Geocres 30M13-140

Re: Proposed Grading Adjacent to
Ontario Hydro Transmission Tower (170)
Highway 407 - W.P. 144-87-00

Re: **Proposed Grading Adjacent
to Ontario Hydro Transmission Tower (170)
Highway 407 - WP 144-87-00
From CNR McMillan Yard Westerly
to Kipling Avenue
District 6 Toronto**

Re: Highway 407 Advanced Structures -
Humber River to Pine Valley Drive
WP 141-87-00
Giffels Project No. W8820501

PLATE No	
CONT No	
WP No 141 - 87 - 00	
PROFILE	
Survey	Revised
Giffels Giffels Associates Limited Consulting Engineers and Architects

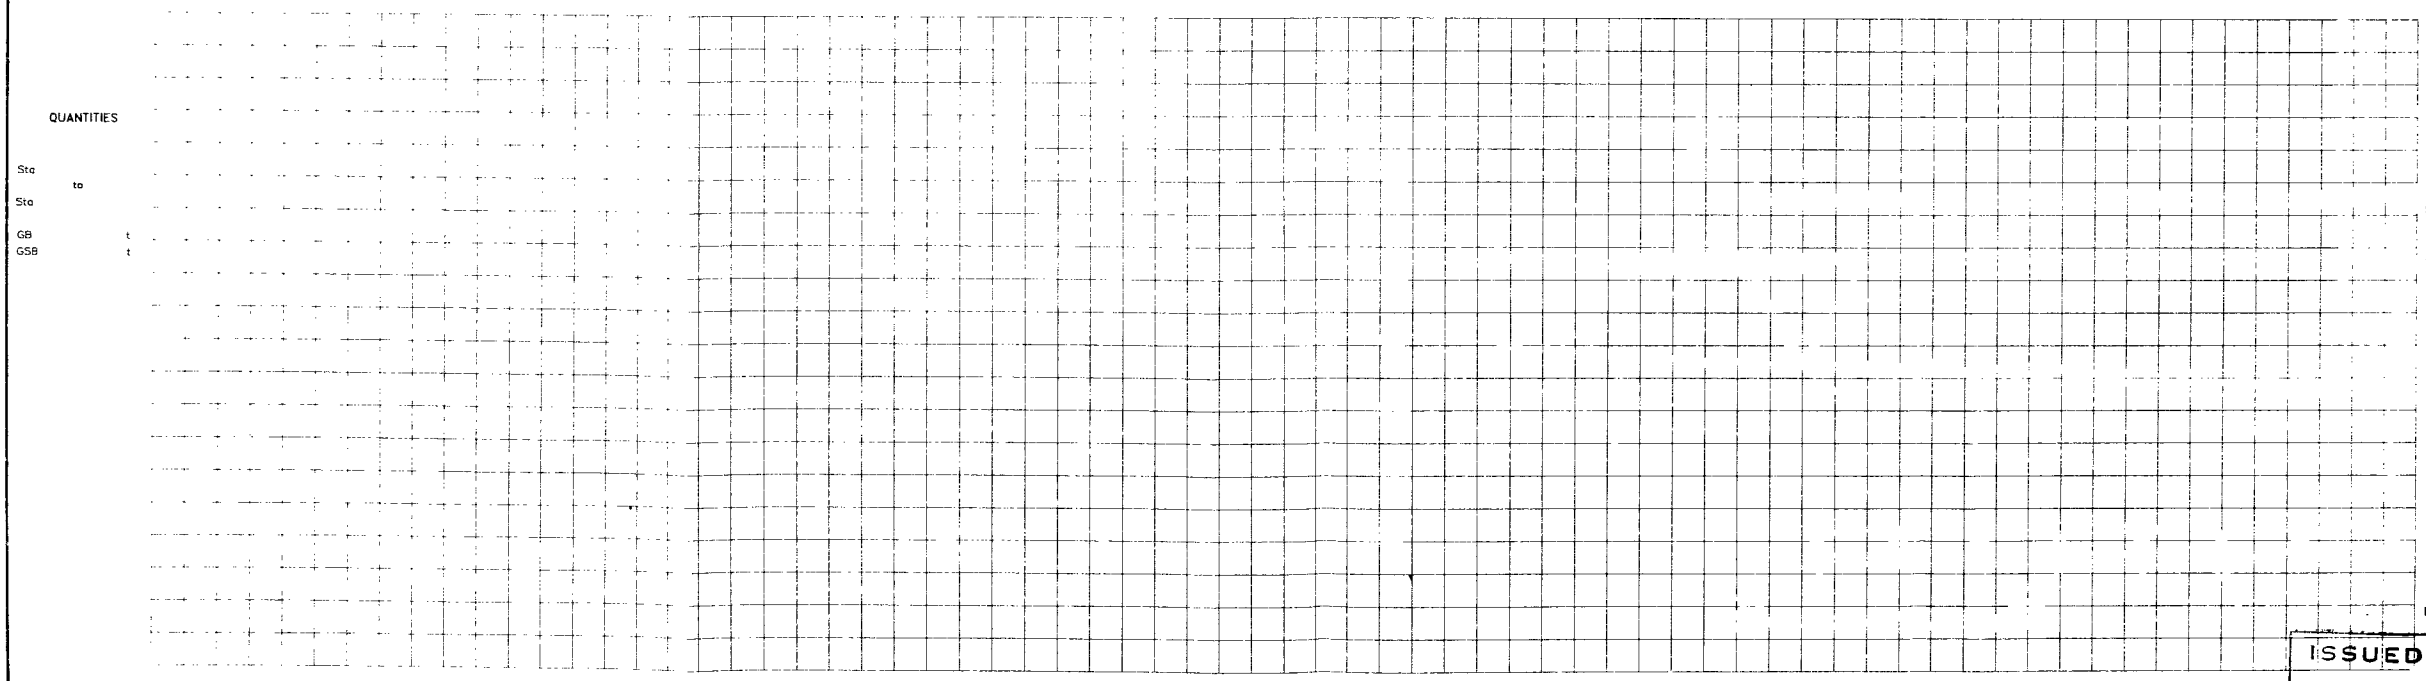
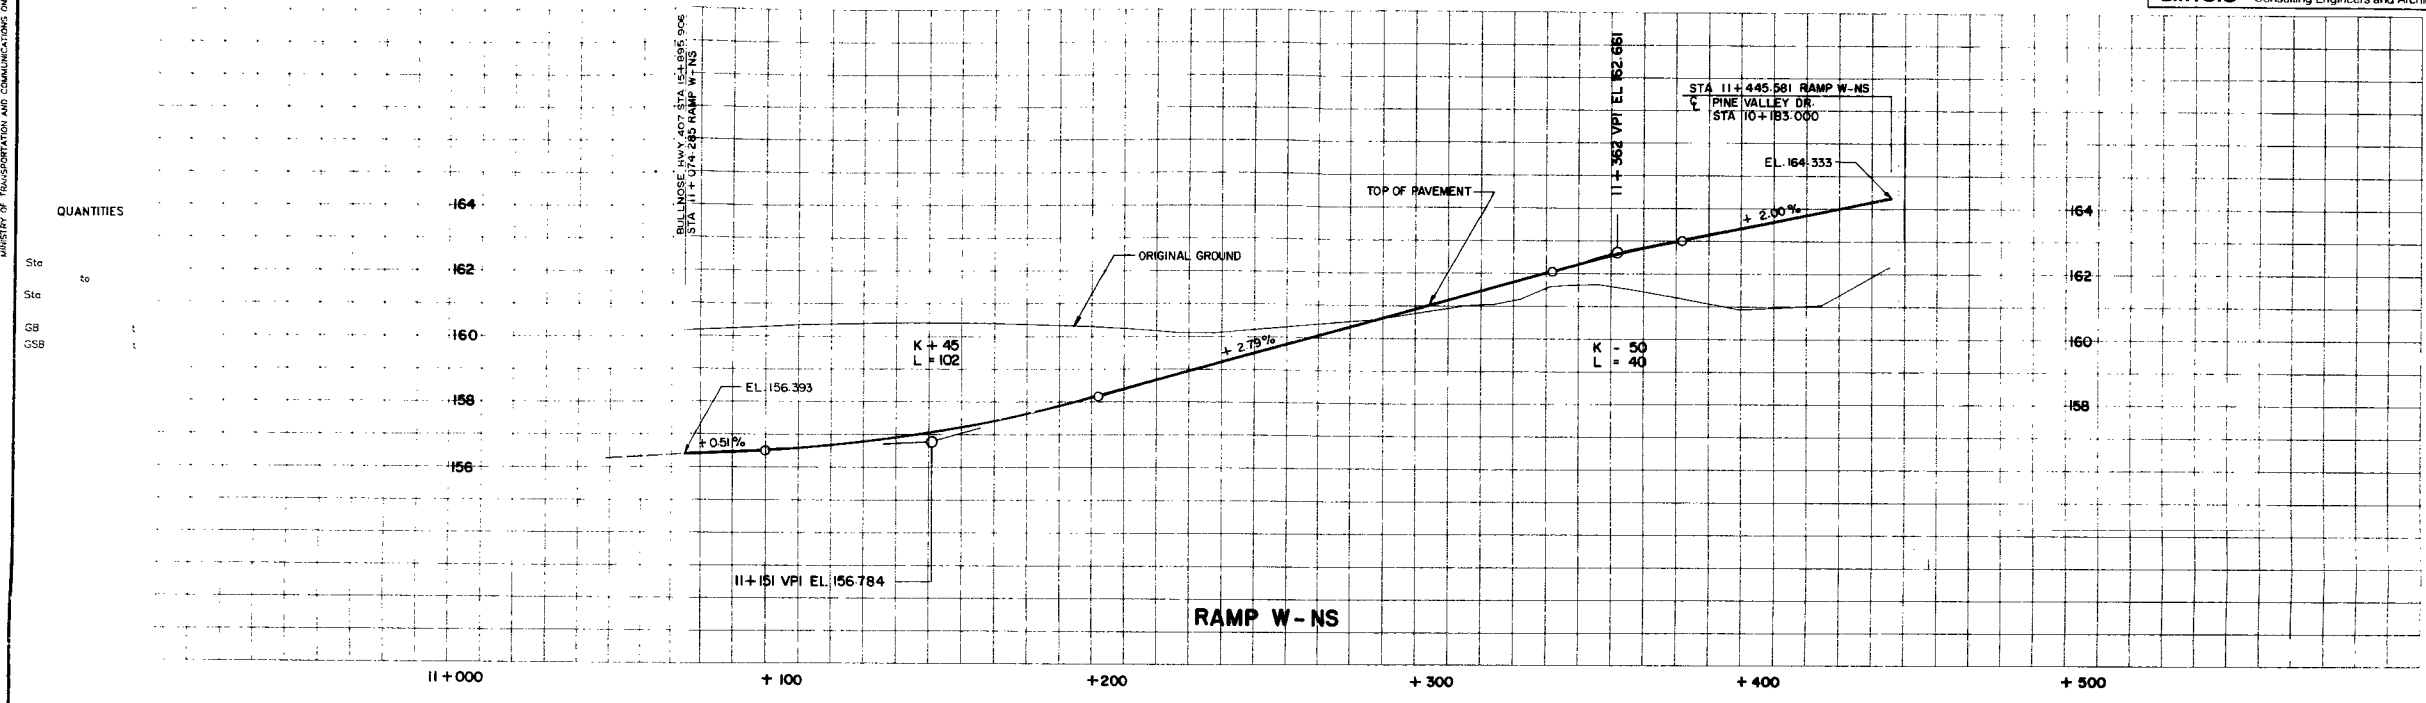
Profile information from Ontario Hydro was not available. We enclose the proposed Pine Valley Drive profile showing the 4 tower lines crossing Pine Valley. Ontario Hydro should review and comment regarding vertical clearances.
